AIR - HP COMPRESSOR VARIABLE STATOR VANE ACTUATOR - INTRODUCTION OF A LINEAR VARIABLE DIFFERENTIAL TRANSFORMER WITH REVISED ADHESIVE TAPE - CATEGORY CODE 7 - MOD.ENG-75-0078

V2500-ENG-75-0078

ENGINE COMPRESSOR CONTROL - VARIABLE STATOR VANE ACTUATOR, INTRODUCTION OF NEW LINEAR VARIABLE DIFFERENTIAL TRANSFORMER (LVDT), REVISED MATERIALS TO PREVENT JOINT DEGRADATION

(LUCAS AEROSPACE MOD. D.TV.058)

Removal and Installation of the LVDT

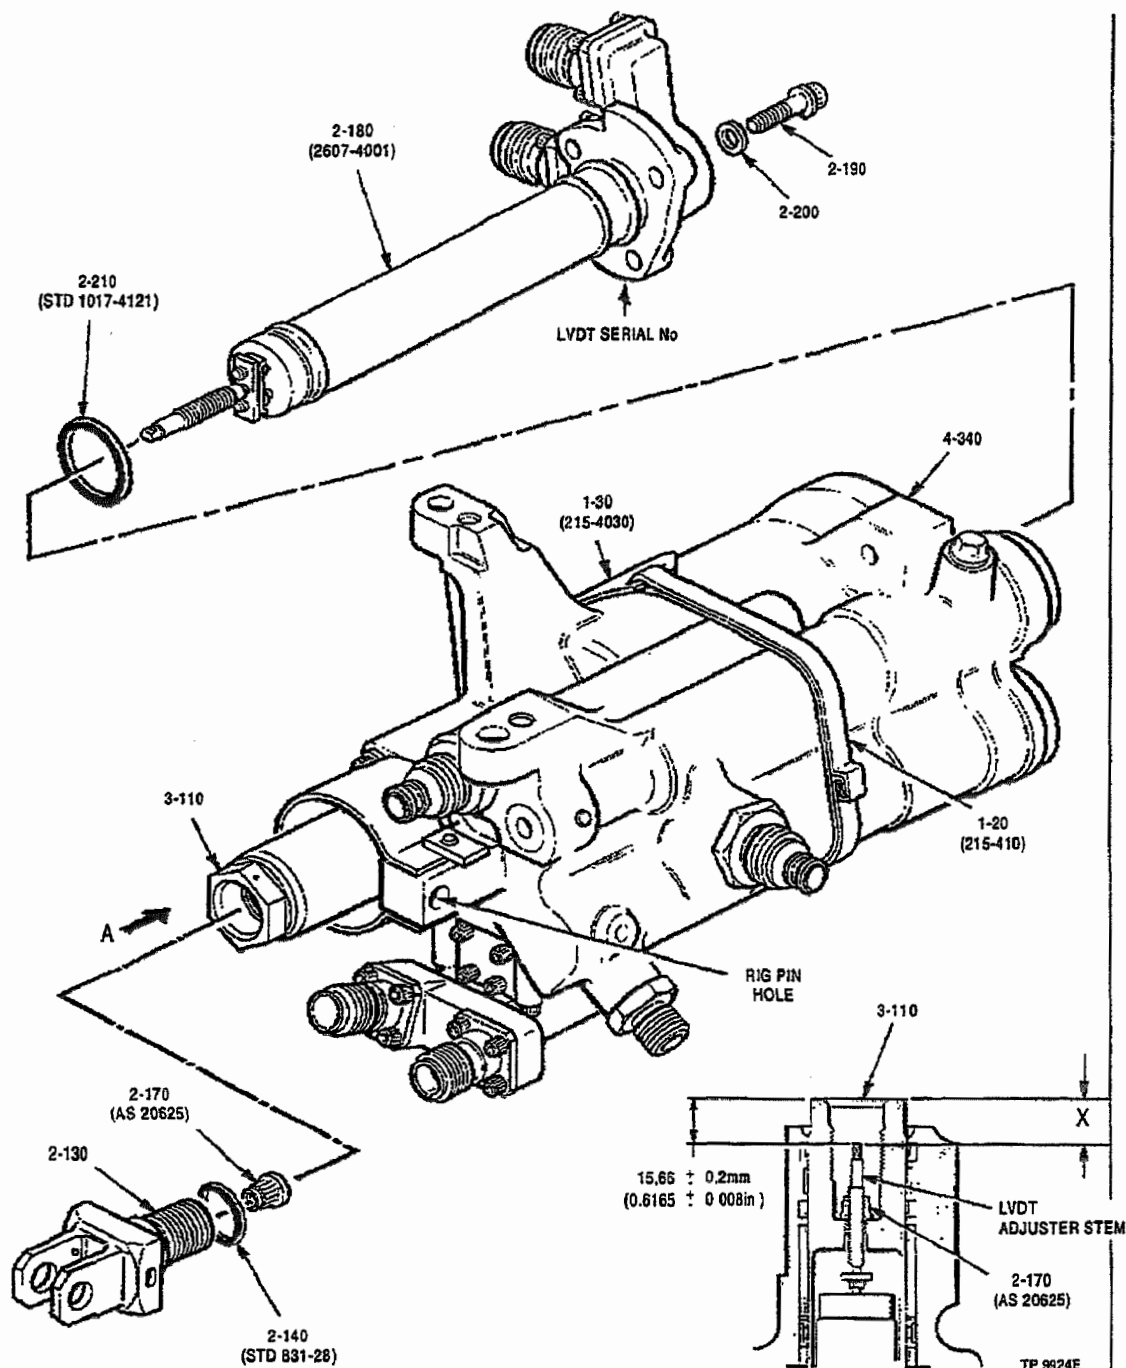
(8) Remove the LVDT, Figure 1

- (a) Install the VSVA on the workholder A.043236 and attach the workholder to a hydraulic clamp or hold it in a vice.
- (b) Extend the ram piston (piston assembly) (3-110) by hand to the fully extended position. Use the reaction tool A.043321 to hold the ram piston and unscrew the fork end with the torque adapter.
- (c) Remove the fork end (2-130) together with the toroidal sealing ring (2-140) from the ram piston (3-110). Remove the toroidal sealing ring (2-140) from the fork end (2-130), discard the toroidal sealing ring.
- (d) Unscrew and remove the self-locking nut (2-170) from the adjuster stem of the LVDT (2-180). Use the adjusting tool A.043222 to hold the LVDT adjuster stem while the self-locking nut (2-170) is unscrewed at the same time. Discard the self-locking nut (2-170).

- (e) Unscrew the LVDT adjuster stem from the ram piston (3-110) (clockwise when viewed from arrow A); use the adjuster part of the tool A.043222.
- (f) Unscrew and remove the three machine bolts (2-190) and the countersunk washers (2-200) which secure the LVDT (2-180) to the body assembly (4-340).
- (g) Remove the LVDT (2-180) from the body assembly (4-340). Remove the toroidal sealing ring (2-210) from the LVDT, discard the toroidal sealing ring.
- (h) The removed LVDT is classified as scrap.

(9) Install the Replacement LVDT, Figure 1

- (i) Use the adjuster part of the tool A.043222 to set the LVDT adjuster stem to a dimension of $15,66 \pm 0,2$ mm (0.6165 ± 0.008 in) as shown on Figure 1. Check with a vernier depth gauge.

LVDT Output Voltage Checks

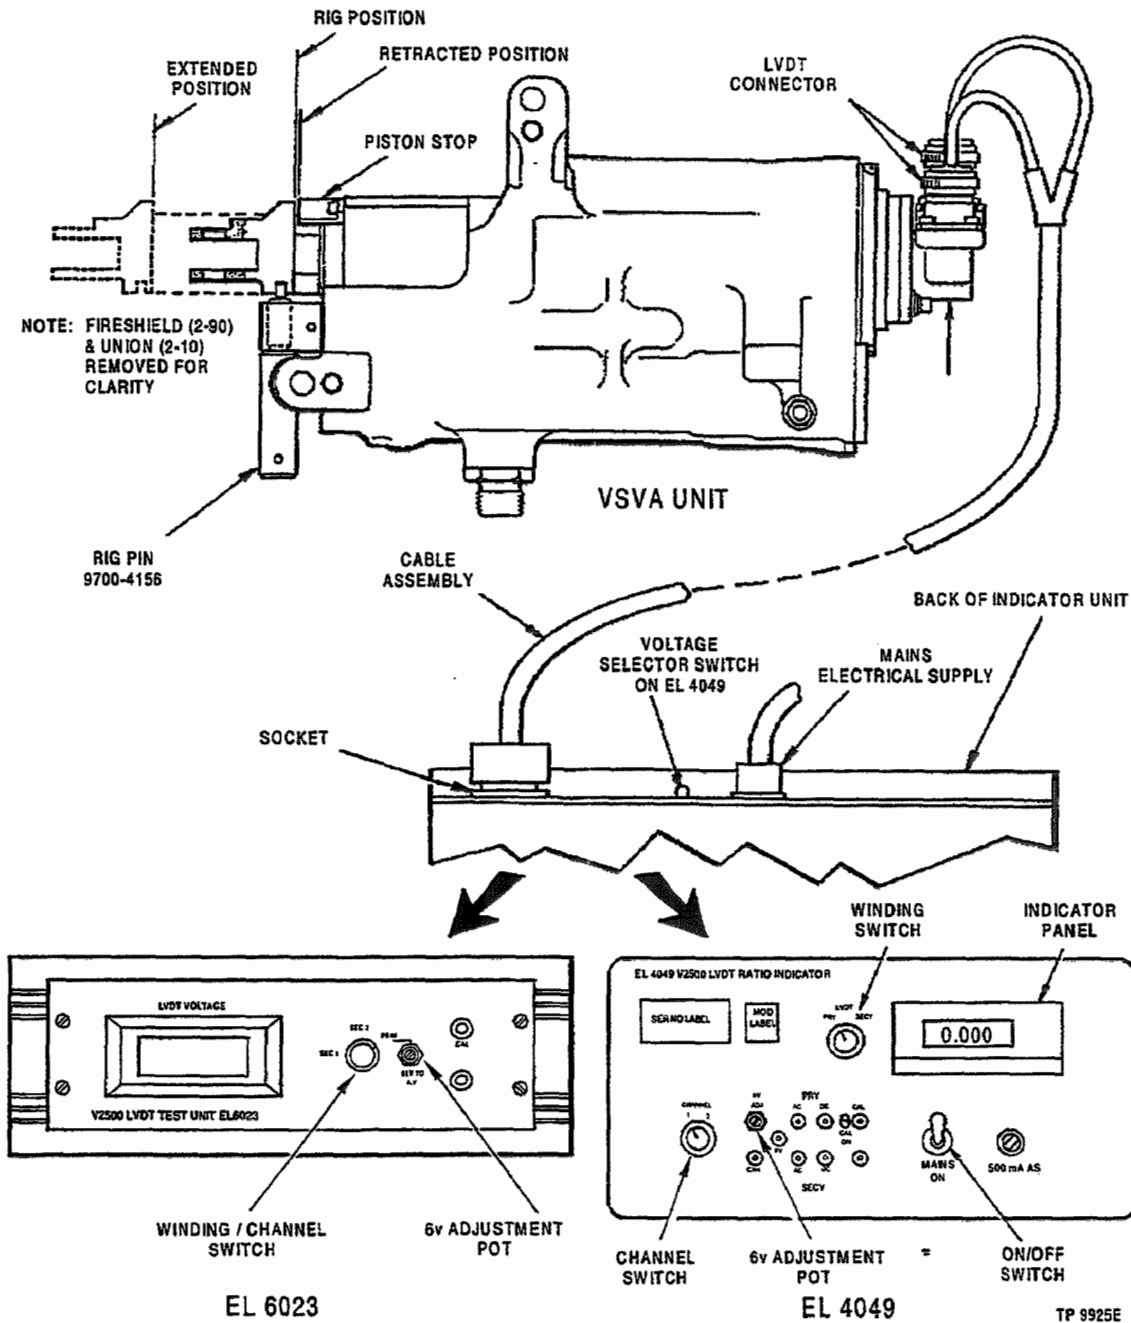
- (10) Check the LVDT Adjustment, Figure 2
- (a) Connect the cable assembly to the socket on the LVDT indicator unit (EL4049) or EL6023, and the Channel 1 and Channel 2 connectors on the VSVA unit.

- NOTE: Channels 1 and 2 are marked on the cable assembly and the connector keyways, make sure of correct assembly.
- (b) If necessary, adjust the energising voltage to 6.000 ± 0.005 v by means of the 6v adjustment potentiometer on the indicator unit; check that the winding switch is in the PRIMARY position.

(11) Adjust the LVDT output voltage, Figures 1 and 2.

Figure 1

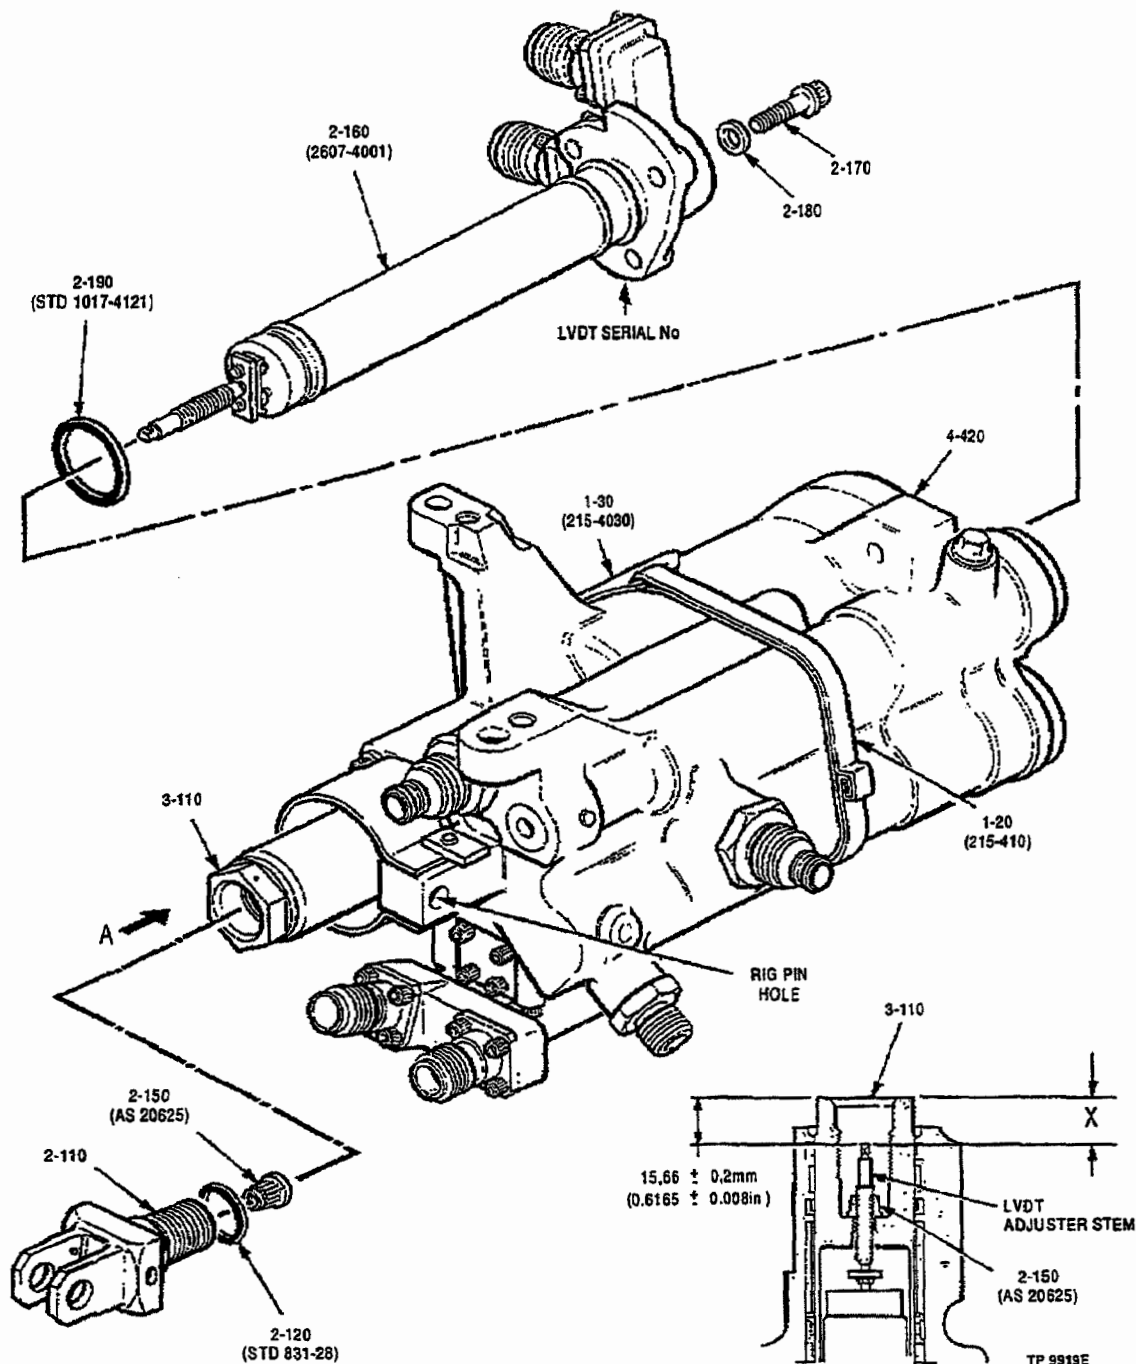
(8) Remove the LVDT, Figure 1

- (a) Install the VSVA on the workholder A.043236 and attach the workholder to a hydraulic clamp or hold it in a vice.
- (b) Extend the ram piston (piston assembly) (3-110) by hand to the fully extended position. Use the reaction tool A.043321 to hold the ram piston and unscrew the fork end with the torque adapter.
- (c) Remove the fork end (2-110) together with the toroidal sealing ring (2-120) from the ram piston (3-110). Remove the toroidal sealing ring (2-120) from the fork end (2-110), discard the toroidal sealing ring.
- (d) Unscrew and remove the self-locking nut (2-150) from the adjuster stem of the LVDT (2-160). Use the adjusting tool A.043222 to hold the LVDT adjuster stem while the self-locking nut (2-150) is unscrewed at the same time. Discard the self-locking nut (2-150).

- (e) Unscrew the LVDT adjuster stem from the ram piston (3-110) (clockwise when viewed from arrow A), use the adjuster part of the tool A.043222.
- (f) Unscrew and remove the three machine bolts (2-170) and the countersunk washers (2-180) which secure the LVDT (2-160) to the body assembly (4-420).
- (g) Remove the LVDT (2-160) from the body assembly (4-420).
- (h) The removed LVDT is classified as scrap.

(9) Install the Replacement LVDT, Figure 1

- (i) Use the adjuster part of the tool A.043222 to set the LVDT adjuster stem to a dimension of $15,66 \pm 0,2$ mm (0.6165 ± 0.008 in) as shown on Figure 1. Check with a vernier depth gauge.

LVDT Output Voltage Checks
Figure 2

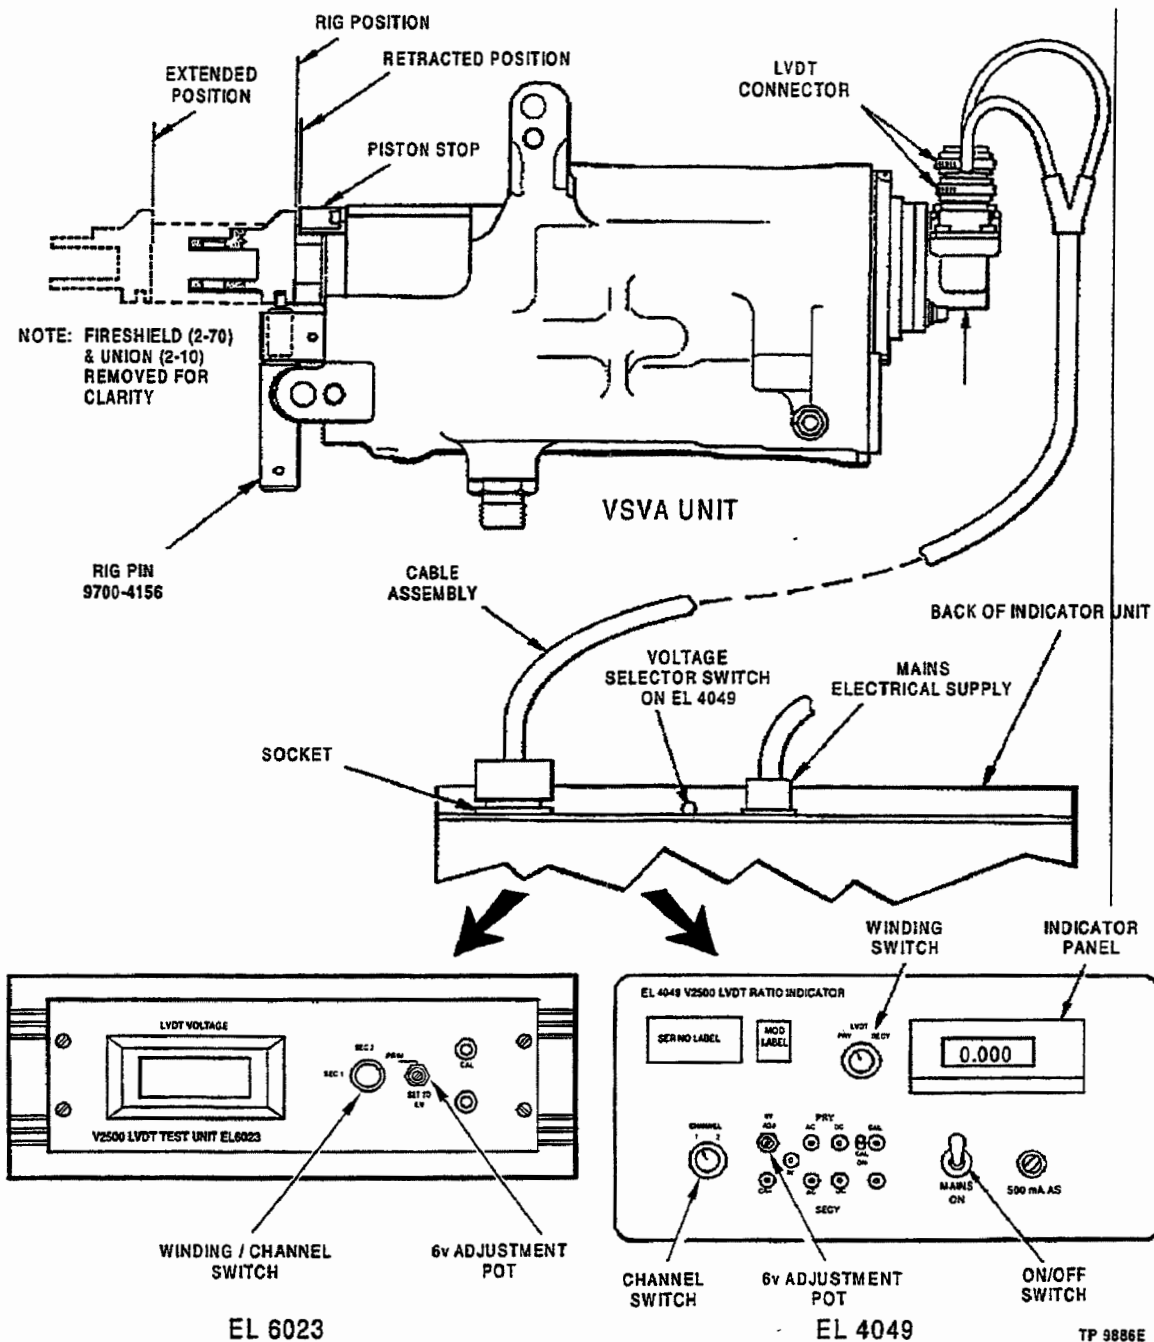
- (10) Check the LVDT Adjustment, Figure 2.
- (a) Connect the cable assembly to the socket on the LVDT indicator unit (EL4049) or EL6023, and the Channel 1 and Channel 2 connectors on the VSVA unit.

- NOTE:** Channels 1 and 2 are marked on the cable assembly and the connector keyways, make sure of correct assembly.
- (b) If necessary, adjust the energising voltage to 6.000 ± 0.005 v by means of the 6v adjustment potentiometer on the indicator unit, check that the winding switch is in the PRIMARY position.
